## **Letter of Response**

The following corrections were made to the plans titled "The Aria":

# THE ARIA

## SCOPE OF WORK: NEW 4 BEDROOM, 3 1/2 BATH SINGLE FAMILY HOME

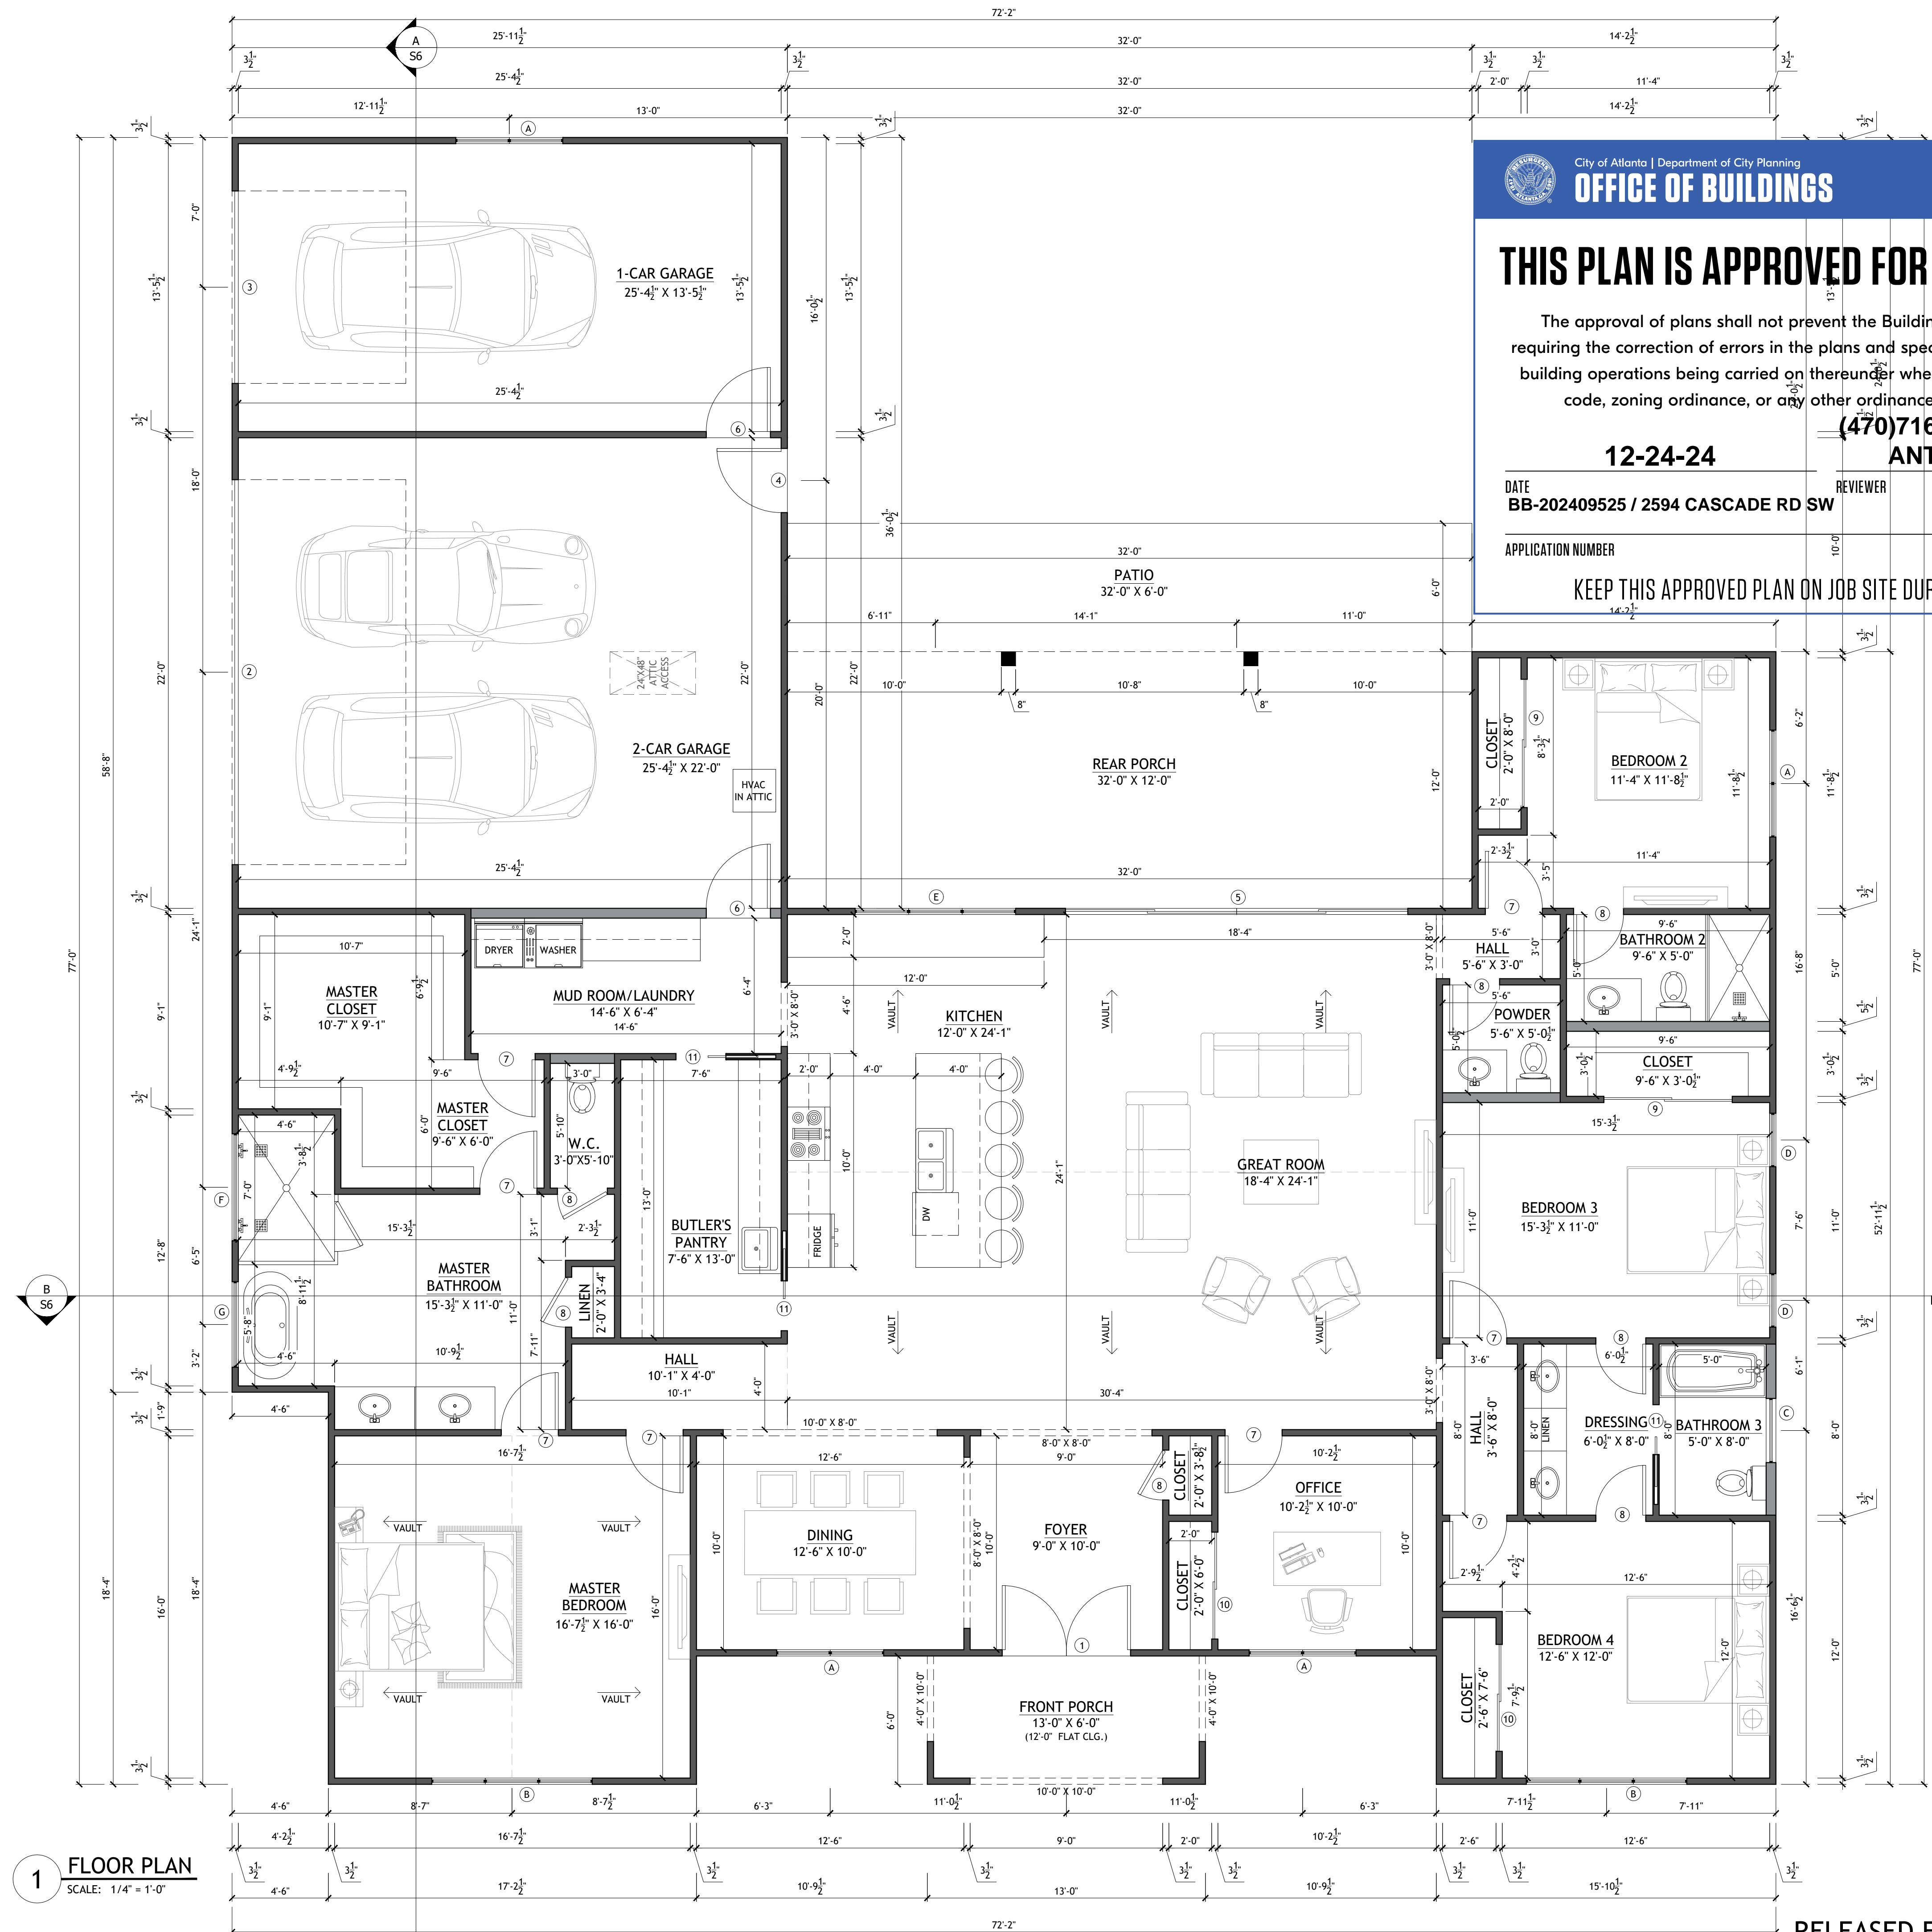
- 1.A demo permit will be applied for by the builder or his representative.
- 2.Window labeled "G" has been labeled as tempered glass to comply with R308.4.5.
- 3.Window schedule has been updated to notate egress to meet requirements of R310.2.
- 4.Stamped Truss package will be uploaded by the builder or applicant.
- 5.Sheet S5 has been updated to show a vapor barrier at slab per R506.2.3.

WINDOW SCHEDULE				
	WIDTH	HEIGHT	QTY.	DESCRIPTION
(A)	5'-0"	6'-0"	4	CASEMENT (DOUBLE) (EGRESS)
(B)	7'-6"	6'-0"	2	CASEMENT (TRIPLE) (EGRESS)
(C)	3'-0"	1'-6"	1	FIXED (TEMPERED GLASS)
(D)	2'-6"	6'-0"	2	CASEMENT (EGRESS)
(E)	7'-6"	4'-0"	1	CASEMENT (TRIPLE) (EGRESS)
(F)	5'-0"	1'-6"	1	TRANSOM (TEMPERED GLASS)
(G)	4'-0"	4'-0"	1	FIXED (TEMPERED GLASS)
